**GE Hitachi Nuclear Energy**

MFN 07-455, Supplement 4

Subject: **Response to Portion of NRC Request for Additional  
Information Letter No. 126 Related to ESBWR Design  
Certification Application, RAI Number 22.5-1 S01**

**RAI Number 22.5-1 S01**

Figure 2.12.3-1. Reactor Component Cooling Water System

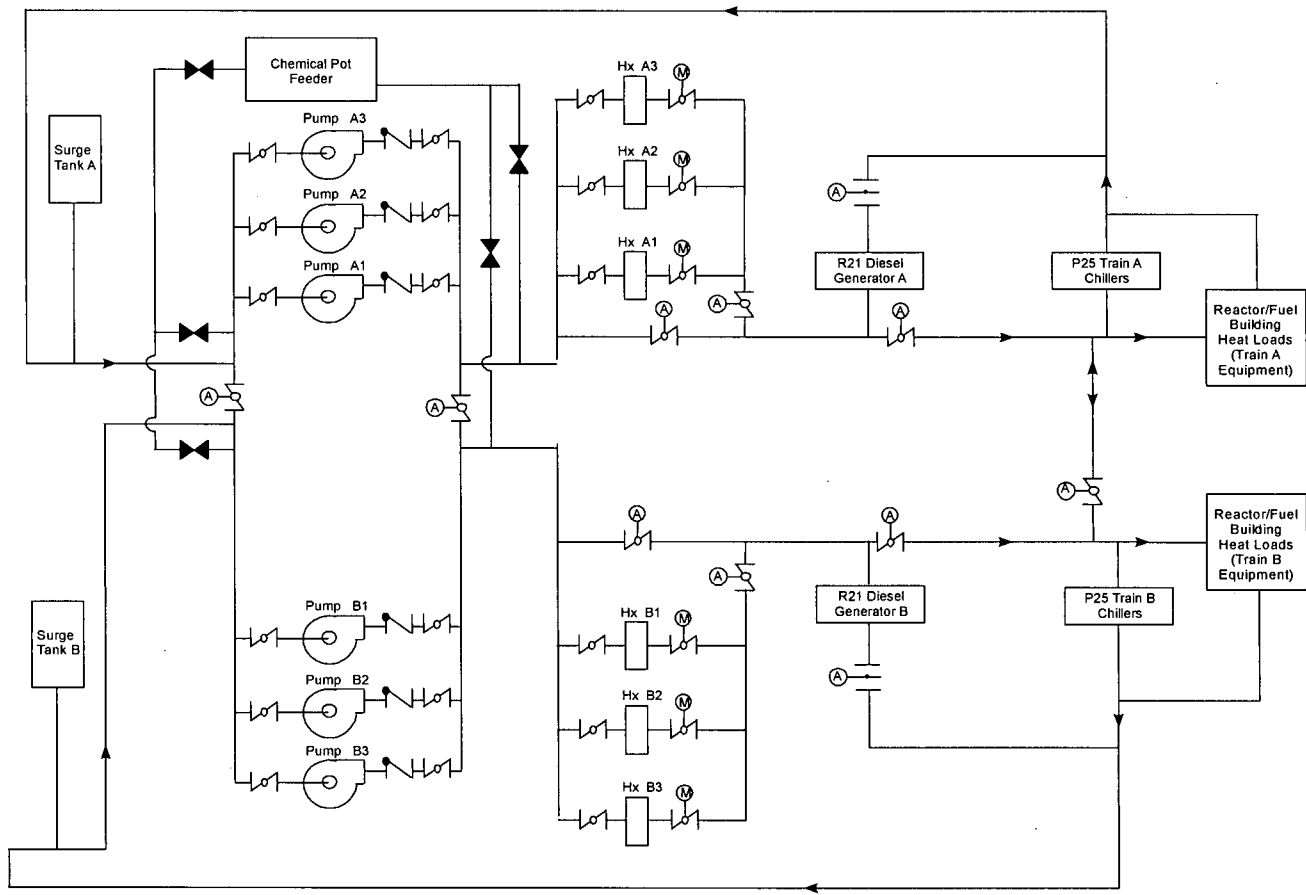
*NRC Summary: Missing a drawing for RCCWS ITAAC*

*In DCD Tier 1, Revision 4, Table 2.12.3-1, Item 1 is not adequate because it does not have a figure to perform as-built system inspection. Provide a schematic of the RCCWS in Tier 1 Section 2.12.3.*

The RCCW System is a nonsafety-related system. However, RCCWS is included under the scope of RTNSS. Therefore, a schematic of the RCCWS is provided in DCD Tier 1, Rev. 5.

DCD Tier 1, Section 2.12.3 will be revised and a schematic for RCCWS is provided. Furthermore, DCD Tier 1, Table 2.12.3-1 will be revised under Revision 5 to reference the added schematic of the RCCWS.

The functional arrangement of the RCCWS is shown on Figure 2.12.3-1.

Design Commitment	Inspections, Tests, Analyses	Acceptance Criteria
1. The RCCWS functional arrangement is described in the Design Description of Section 2.12.3 <u>and is shown on Figure 2.12.3-1.</u>	Inspection of the as-built system will be performed.	Report(s) document that the as-built RCCWS System conforms to the functional arrangement described in the Design Description of this Section 2.12.3 <u>and as shown on Figure 2.12.3-1.</u>
